IN THE DRAWINGS:

ANNOTATED SHEET SHOWING CHANGES

Fig. 1

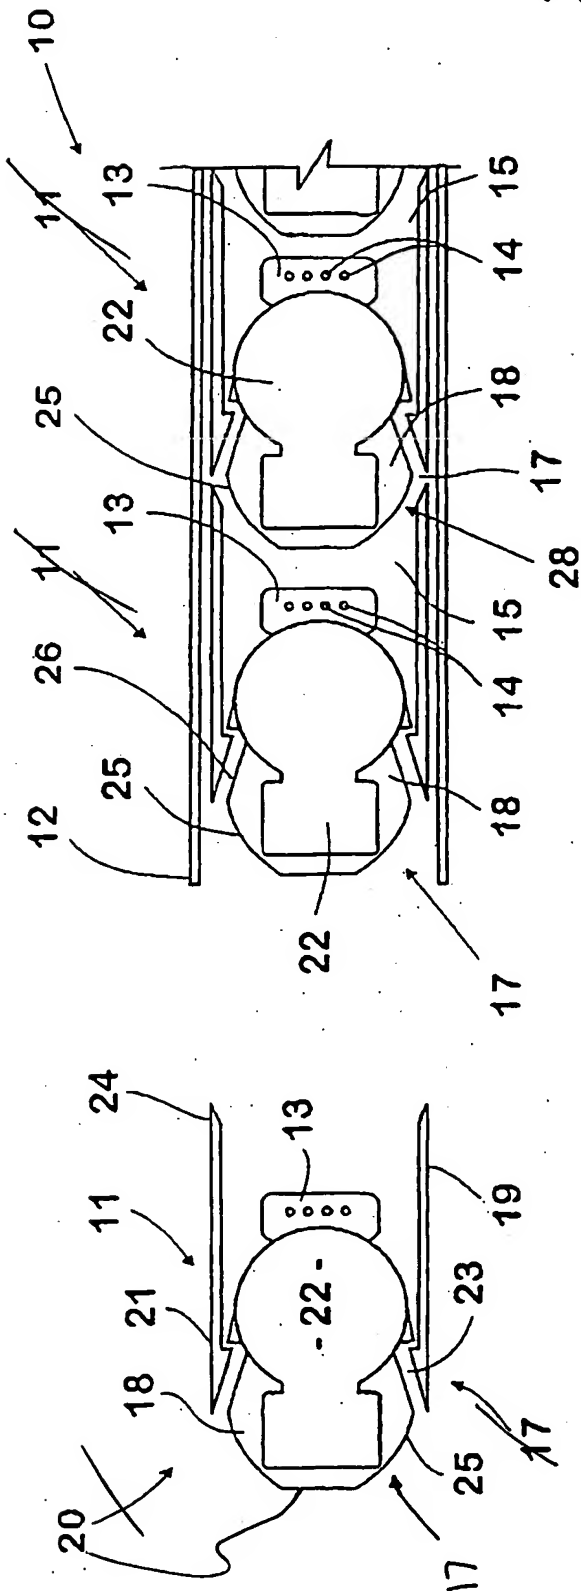
Subject to the approval of the Examiner, it is respectfully requested that Figs. 1-5 be amended to correct certain reference numeral errors and to improve clarity. The proposed changes are supported by the originally-filed specification and are indicated in red on the attached copy of Figs. 1-5. These drawing changes were approved by the Examiner in the parent application, Application No. 09/958,465. Additionally, it is respectfully requested that Figs. 1-11 be amended to delete "SUBSTITUTE SHEET (RULE 26)" from the footer and other PCT information from the header of the drawings.
